# Access Compliance Report

## Public Rights-of-Way

| Intersection ID: 15397                  | Main Street: N_WENDOVER_RD | Cross Street: N_WENDOVER_RD_RA          | Location: SE           |
| ADA ID: 25FEDE914253                    | Ramp Type: Perp            | Initial Pass/Fail: Fail                 | Overall Compliance: No |

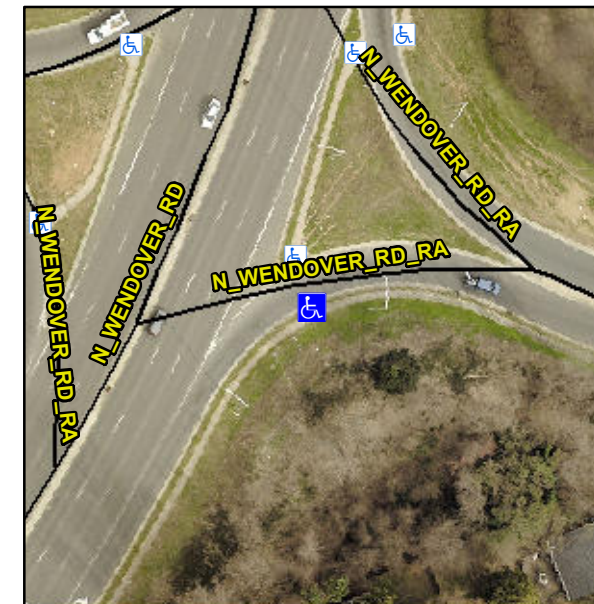
**Not Found, R304.5.1**

| Compliance | Description           | Data | Compliance | Description                 | Data |
|------------|-----------------------|------|------------|-----------------------------|------|
| No         | Ramp Width (in)       | 41.5 | Yes        | Ramp XSlope (%)             | 1.1  |

**Remove & Replace Entire Ramp.**
